**Re: Geiger Hill
(Griffiss Business and Tech Park –
Proposed Commercial Development)
Response to Comments**

On behalf of Indus Hospitality Group (“Indus”), we have reviewed your staff review comments for the above-referenced project dated April 2, 2026. On behalf of the developer, we offer the following responses for the City’s consideration:

LANDSCAPE PLAN

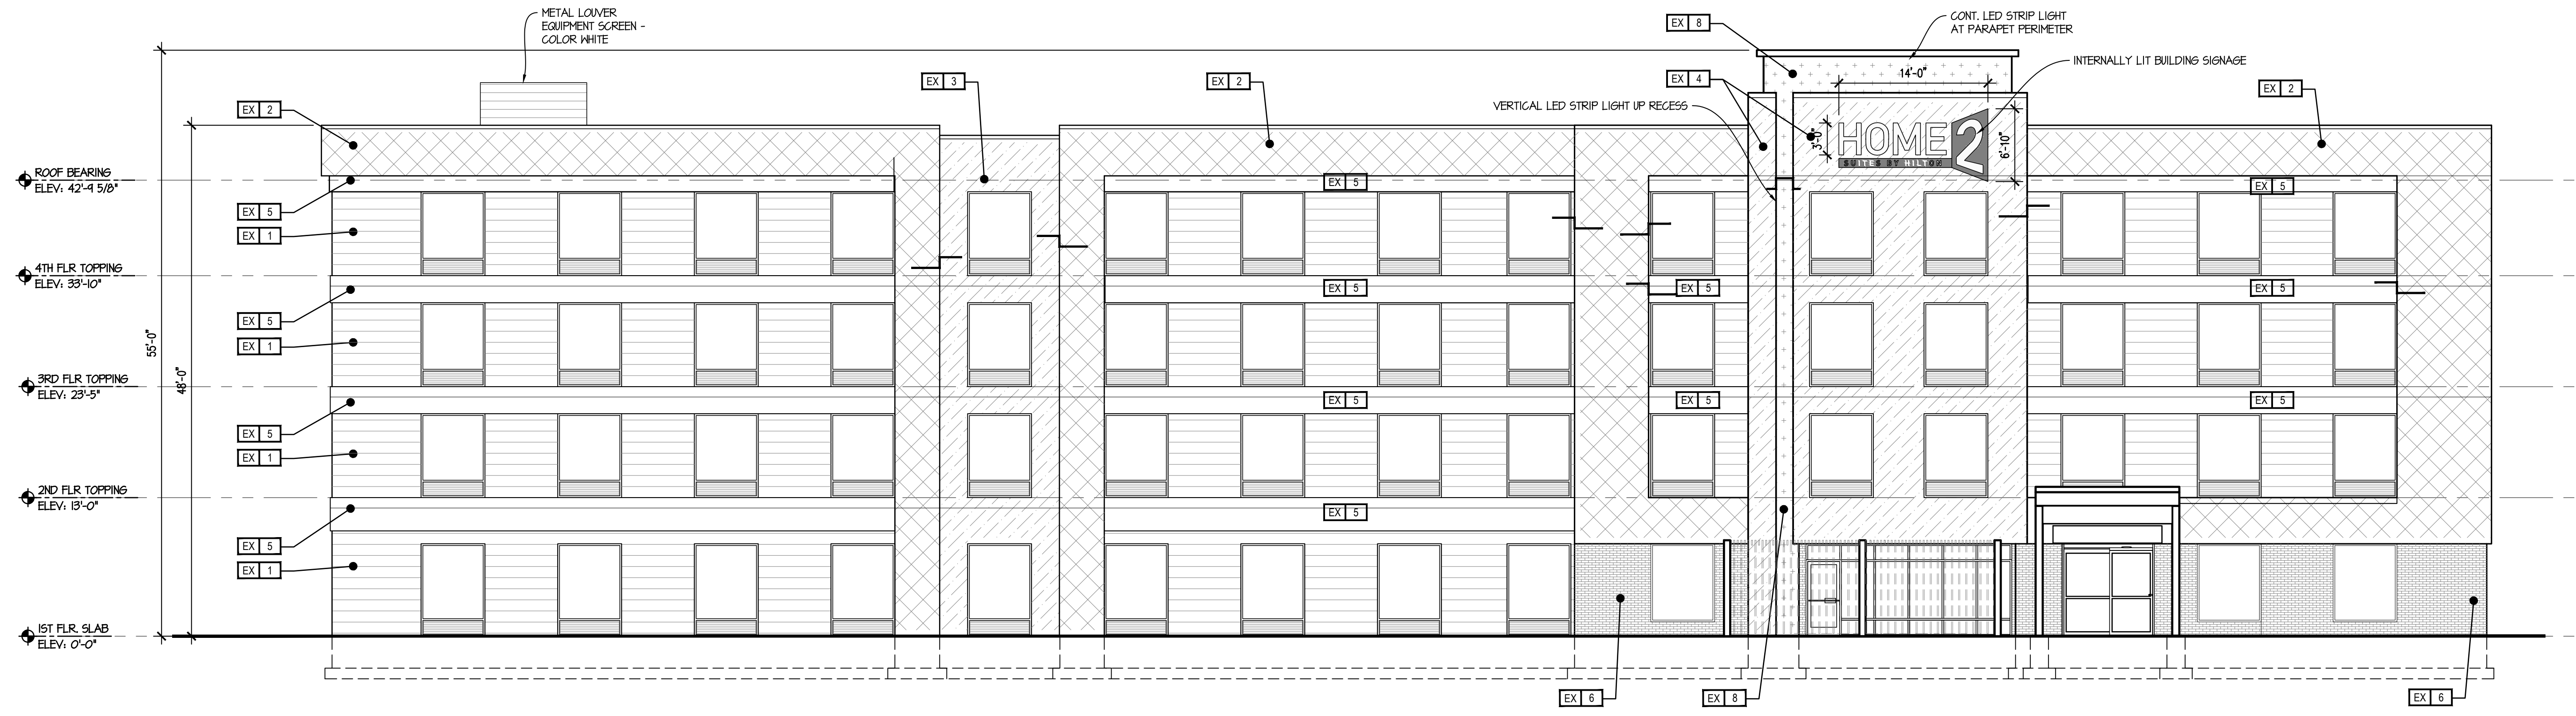
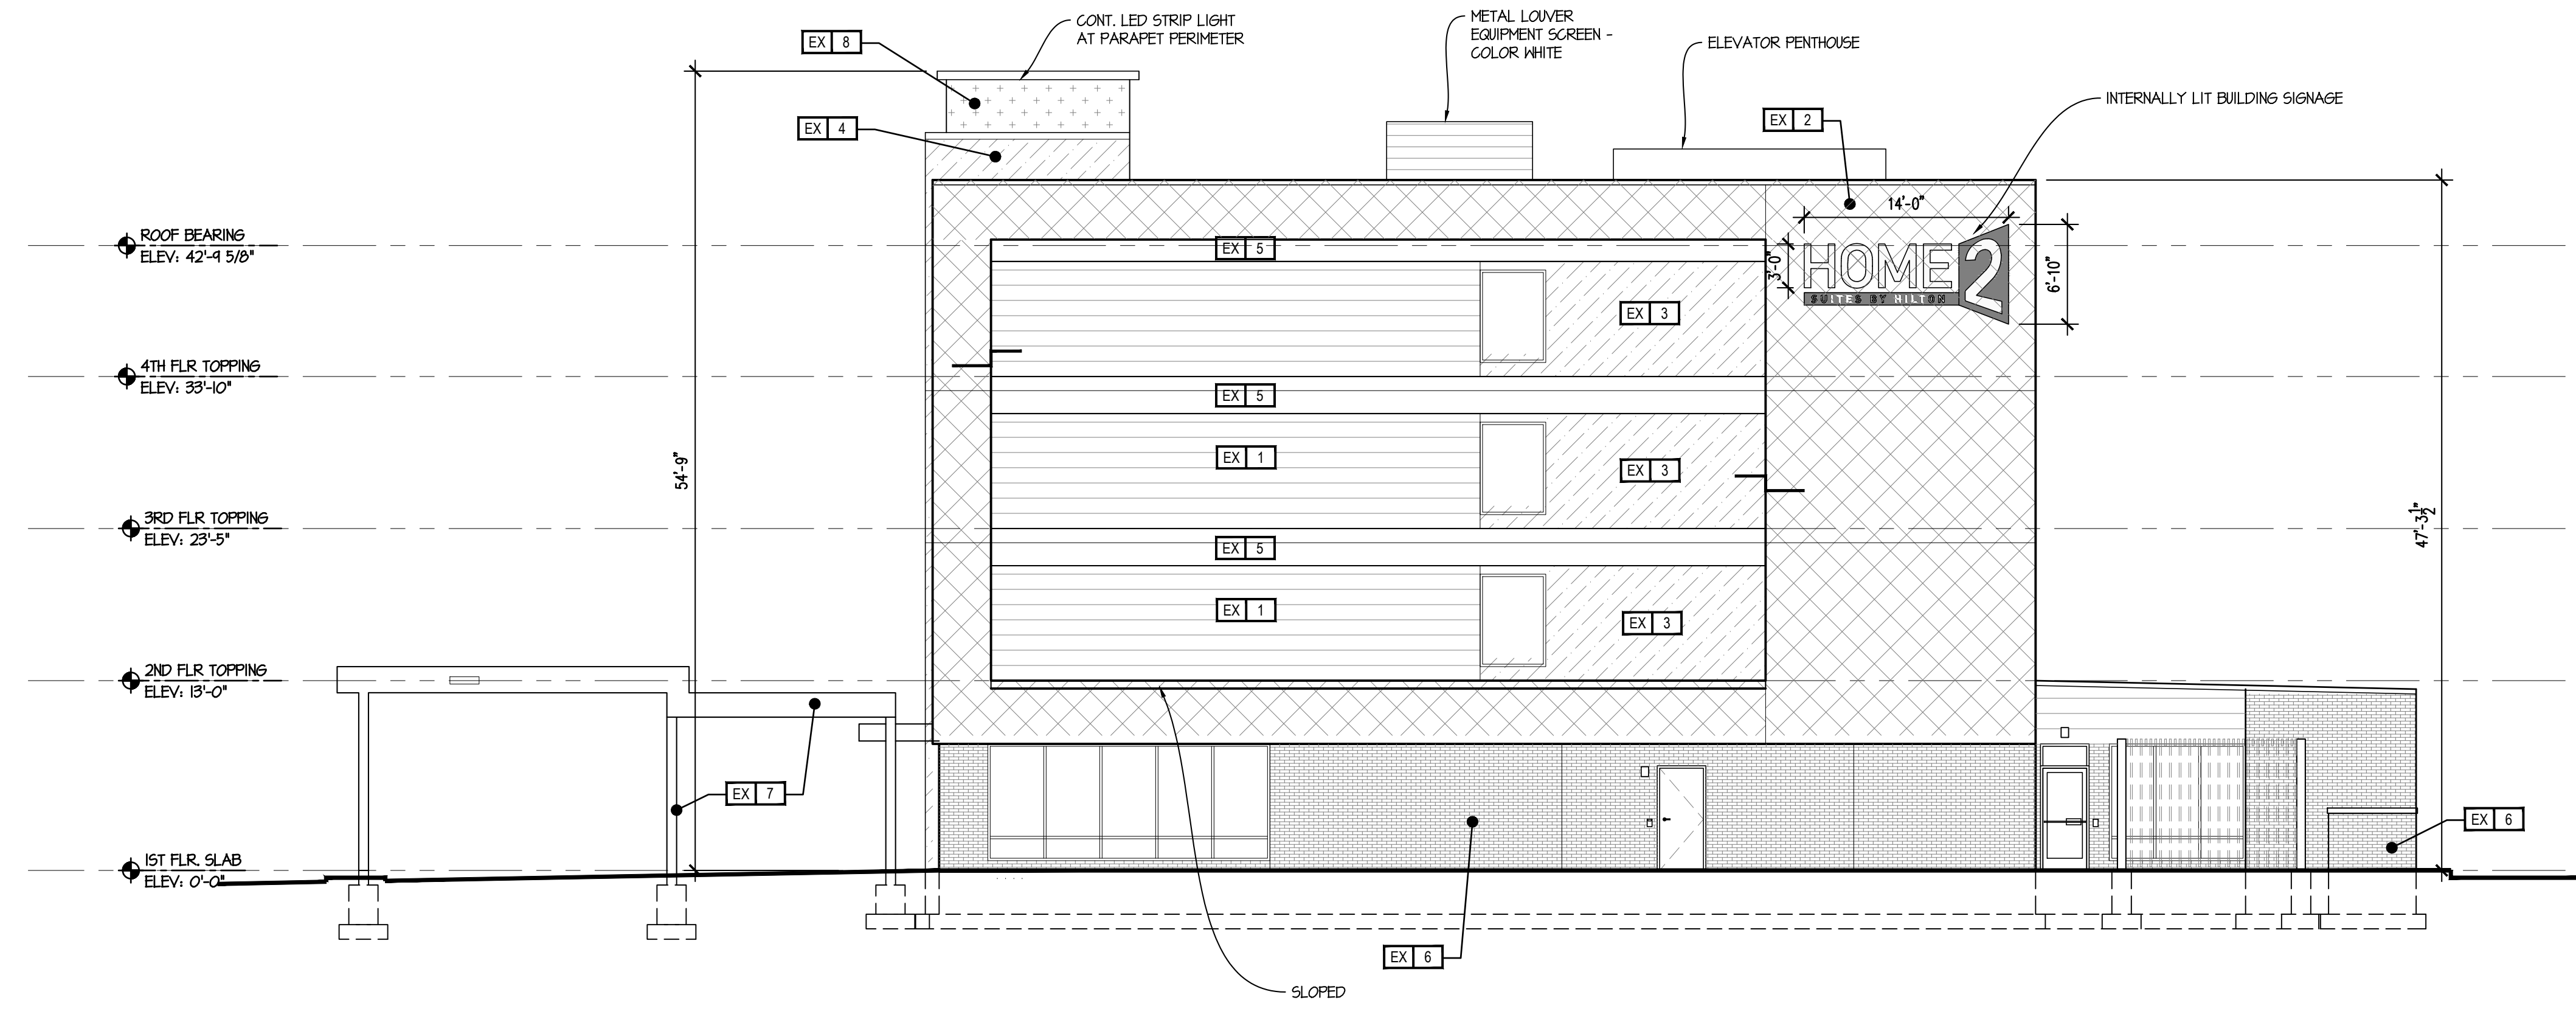
5. Please ensure the specifications for size at planting for all landscaping items complies with the minimums established in Section 80-15.4.

6. Per Section 80-15.9, one tree lawn tree is required for every 30 linear feet. This project has approximately 620 linear feet of tree lawn along Hill Road, which equates to approximately 20 shade trees along the tree lawn area, but the submitted plans only show six shade trees for that area. Please update in accordance with the requirements of Section 80-15.9.

The proposed deciduous shade trees will be 2.5"-3" caliper size and the proposed shrub size will be 18" minimum height to comply with the minimums established in Section 80-15.4. The ornamental deciduous trees are proposed at 1.5" to 2" caliper size to reduce transplant shock at the time of installation and ensure stable establishment. The enclosed Landscape Plan details this.

The tree lawn area located along N.Y. Route 825 is an existing N.Y.S.D.O.T. right-of-way that contains existing underground utilities, light poles, and signage. The number of trees proposed along the frontage boundary of the site has been increased from six (6) to twelve (12) in an effort to comply with the requirements of Section 80-15.9. The area in question contains multiple underground existing utilities within utility easements, approximately five (5) light poles, and multiple NYSDOT highway and directional signs, likely unable to relocate. In order to prevent disrupting viewsheds along N.Y. Route 825 when entering the existing round-about intersection we would suggest not planting trees in this area. Furthermore, the location and width of the existing and proposed sidewalk prevent the planting of trees between sidewalk and the curb. Additional trees have been proposed along the interior lot lines of the site (60 total) to offset the eight (8) remaining trees required along the frontage. Due to the existing conflicts along the frontage of the property, we would request a waiver from this request.

HOME2 SUITES BY HILTON

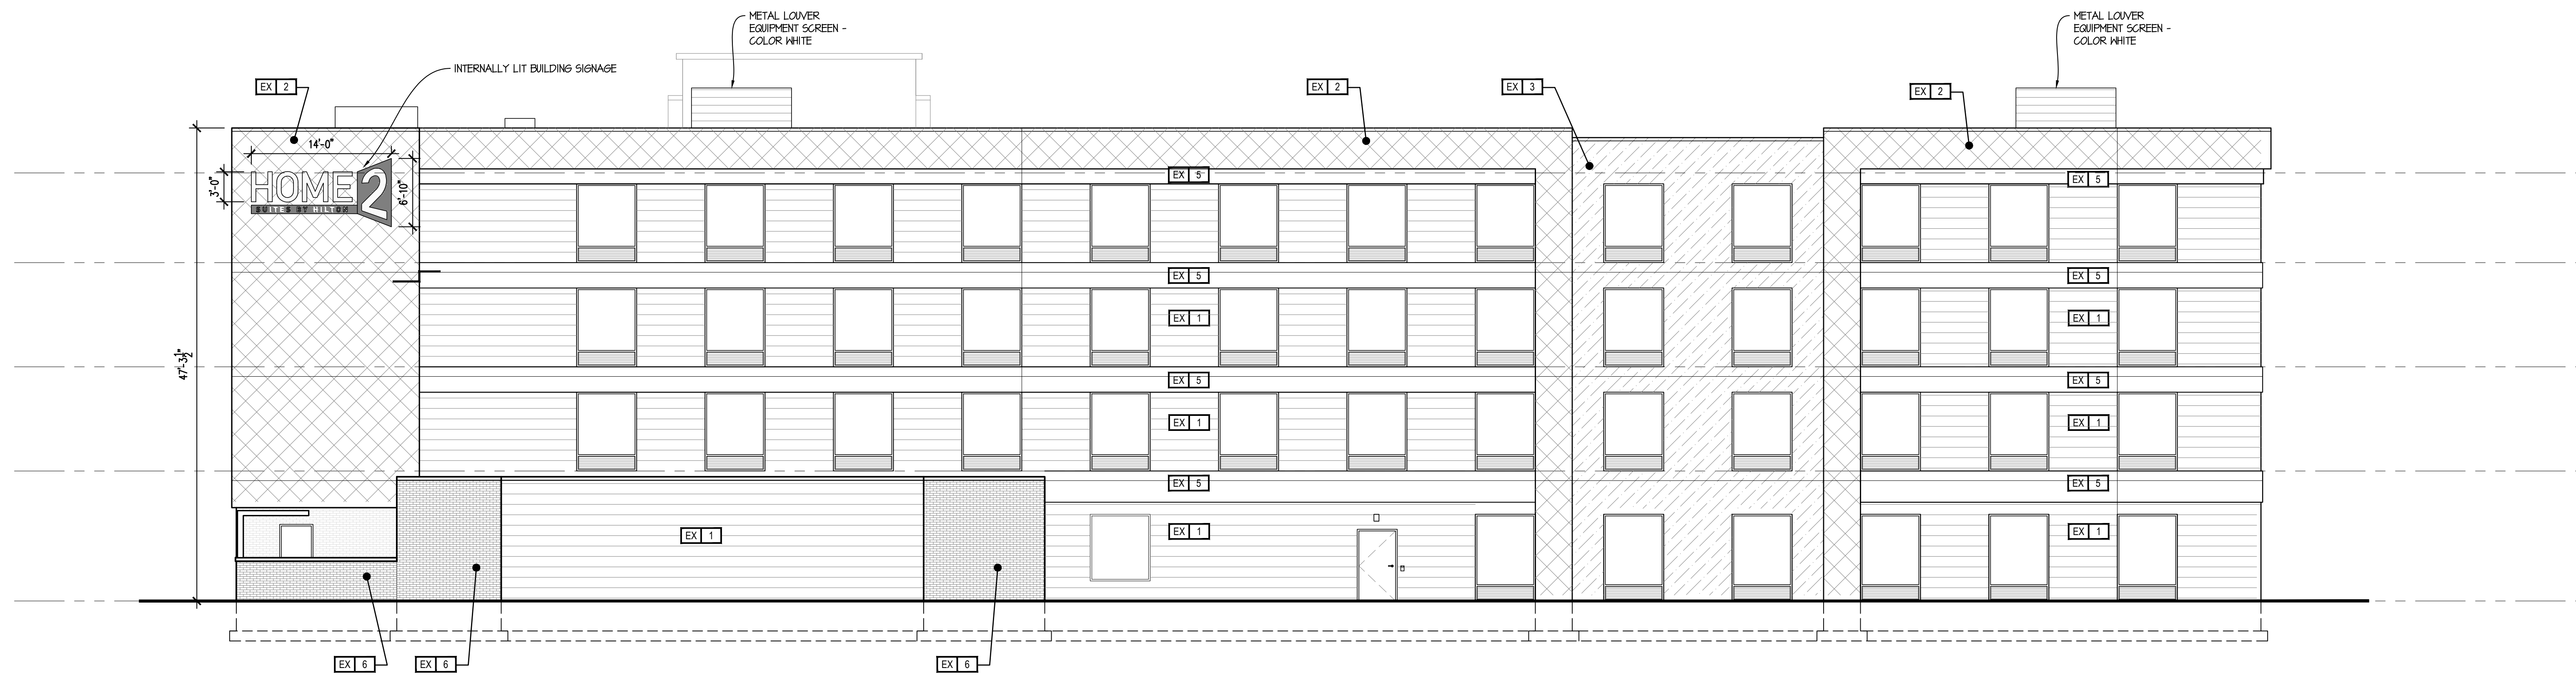
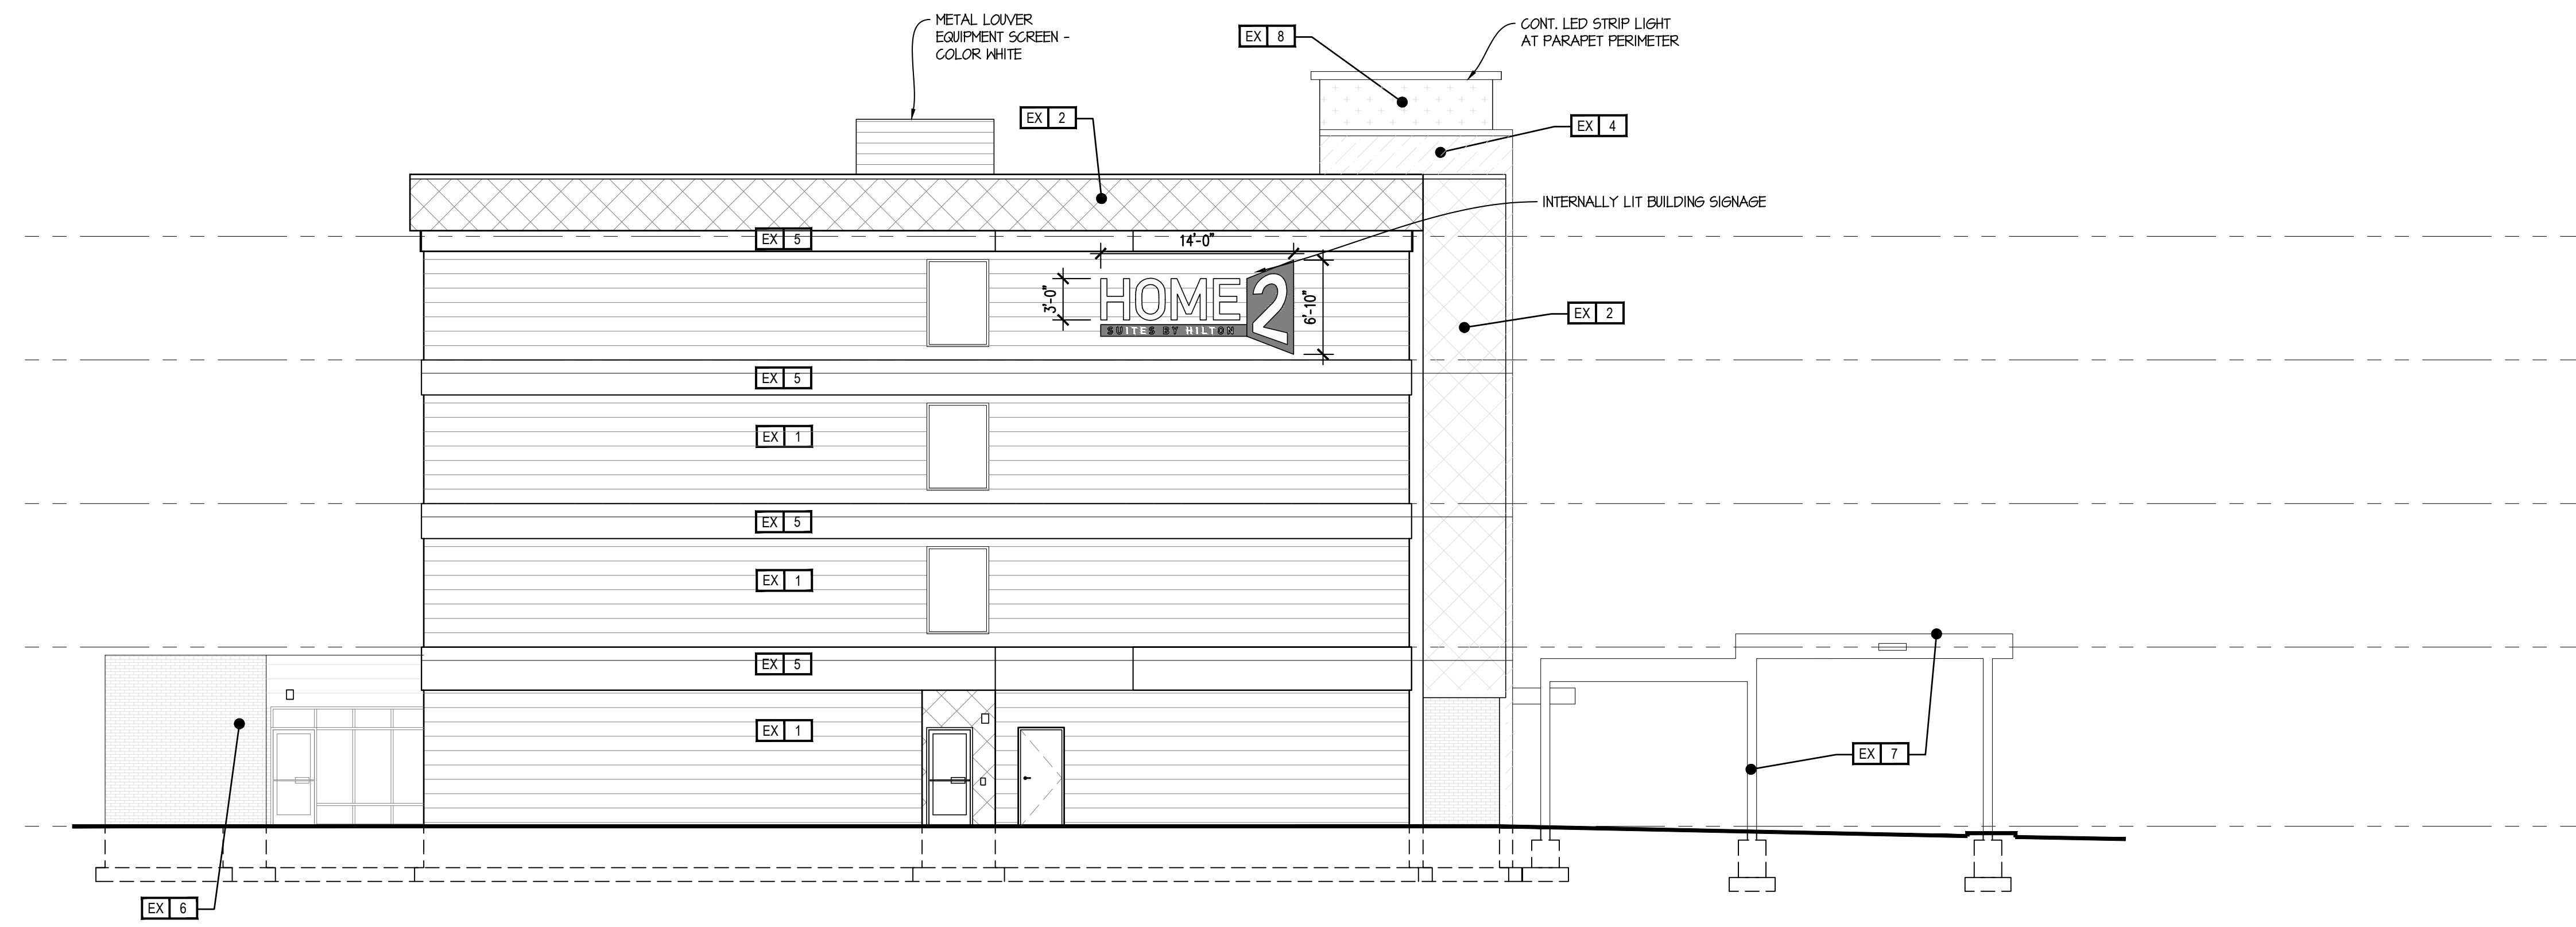
3. Please include to-scale architectural elevations for all proposed buildings and confirm that they comply with the design requirements laid out in Section 80-11.4 of the Zoning Code.

A complete final sign package will be submitted under separate cover and if possible during the building permit process. Building signage has been shown on the architectural elevations enclosed to show intent. The signage located on the hotels are per each brand’s design and may require variances. The site plan also indicates free standing directional signs located at the entrance which will be ‘enter’ and ‘exit’ signs. These monument signs would be designed to meet the code requirements Each lot will have monument sign on their lot as allowed per Code.

Updated architectural elevations of all proposed buildings are enclosed for the City’s review. As mentioned above, the signage is per the hotel brand’s prototypical design.
